TOWNSHIP OF NORTH BRUNSWICK
710 HERMANN ROAD
NORTH BRUNSWICK, NJ 08902

MEMORANDUM

SUBJECT: Block: 257 Lot(s): 10
Street Address: 359 Tremont Avenue
Applicant: Ms. Julie Langsam

I have reviewed the land use application for setback and principal building coverage variances at the above referenced address, and I am issuing the following report.

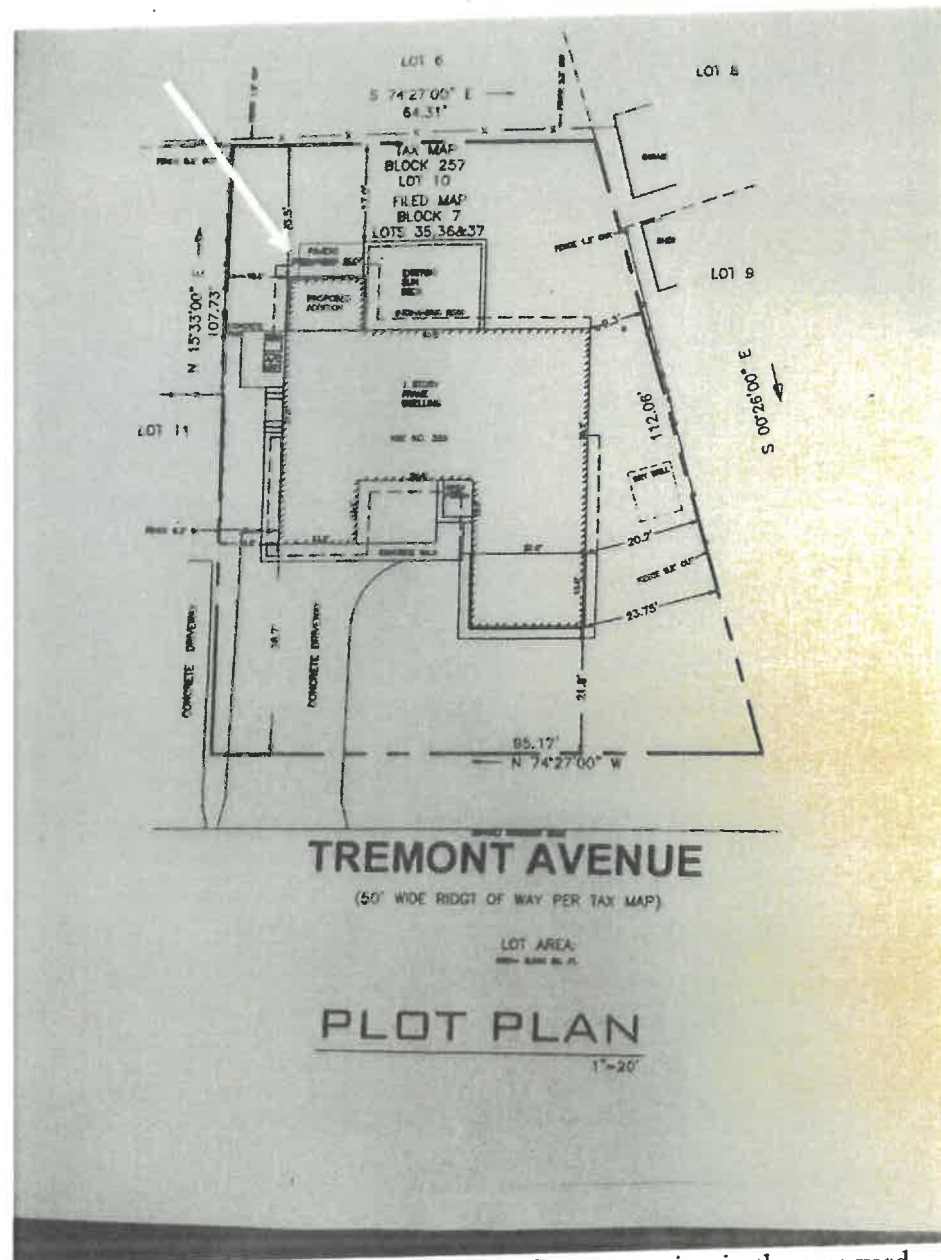
Area of the 13' by 20' (260 sf) one-story front yard addition approved by the ZBA in 2018.

Area of the proposed 13'.7" by 10' ft. kitchen expansion in the rear yard.
